TMC 18.28 TUC District Zoning Regulations Issues Matrix

Page numbers are from the documents included in the binders and used for the 4/3/14 Council Work Session.

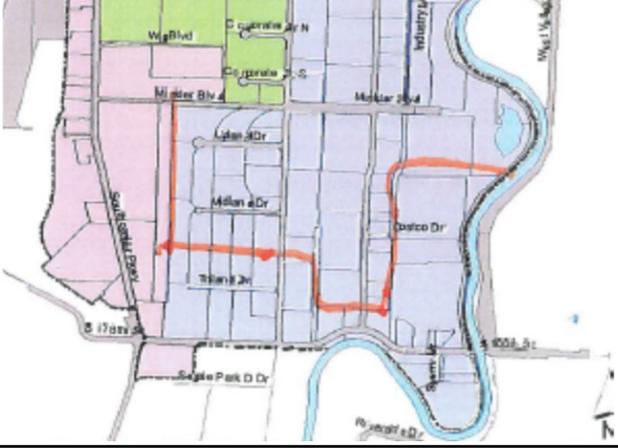
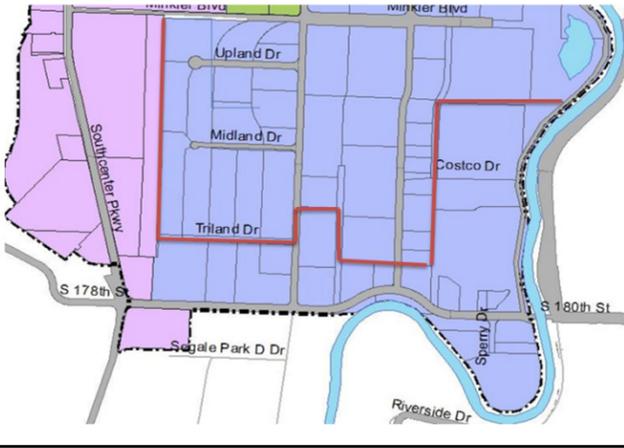
p. 3, 18.28.020.B.4	Add: <u>c. For structures proposed on a single lot where more than one corridor applies, only one building side shall be required to constitute the public "front-door." Modification requests to allow back-of-house functionality shall be liberally granted, subject to the back-of-house screening guidance set forth in [new section of design manual]. Where more than two corridor types apply to a property, (i) no structure shall be required to meet more than two distinct corridor standards, (ii) the applicant shall be allowed to select the front door corridor type, consistent with subsection 18.28.160.C, and (iii) the applicant may select a second corridor type to apply to multiple building sides and/or be allowed design flexibility through the modifications procedure at TMC 18.28.130.C.</u>	A.Gygi, Target, letter 4.28.14	Staff Recommendation: Make the changes underlined below. The intent of having corridor standards is to provide continuity along both sides of a street. Allowing each property owner to select a different corridor type for his frontages would result in sidewalks that jog back and forth and inconsistent landscaping. The corner issue is discussed at p. 35 18.28.160 C which could be modified to address some of Target's concerns: C. Corner Parcels New buildings located at the intersection of two or more Corridors where Building Orientation is required shall have an entrance(s) oriented towards at least one Corridor to be determined by the developer. 18.28.200 C. Add a New Section: <u>5. On sites where all sides of a building are subject to Corridor standards per 18.28.020 B. 4 a. ground level transparency may be waived for the facade facing the least travelled Corridor.</u> The Design Manual already contains a section on service areas. Example of service façade with design elements

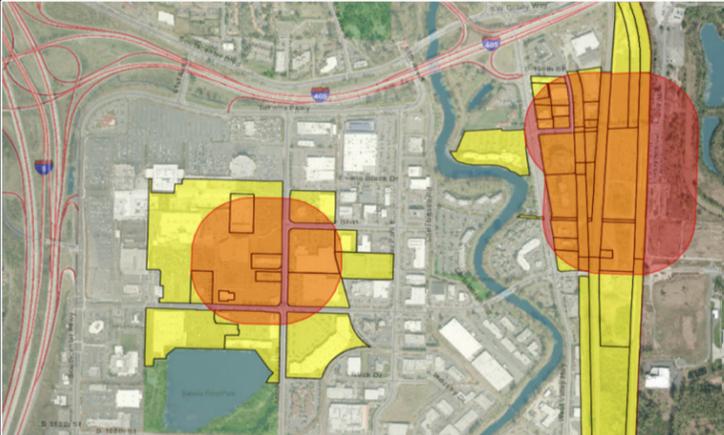
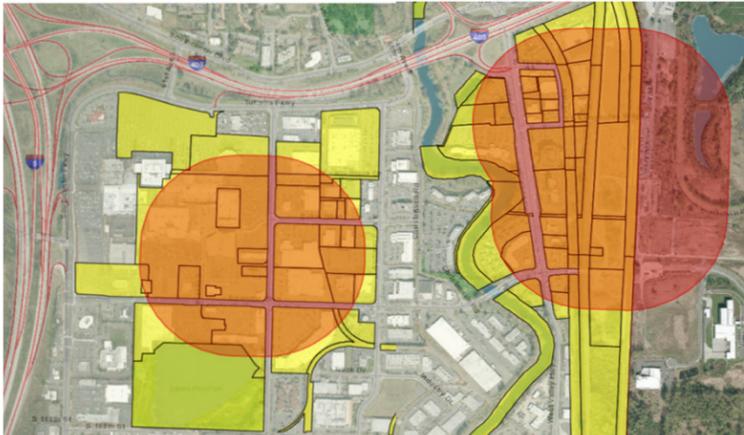
p. 10, Fig. 16 District Map	Expand the boundaries of the Commercial Corridor District (see below)	D.Robertson, letter 4.28.14	Staff Response: This would make a number of existing warehouse, manufacturing and distribution businesses non-conforming. The proposal below would lessen that issue. However the revised area would still make the Costco Optical Lab and Electrical Distributing businesses non-conforming.
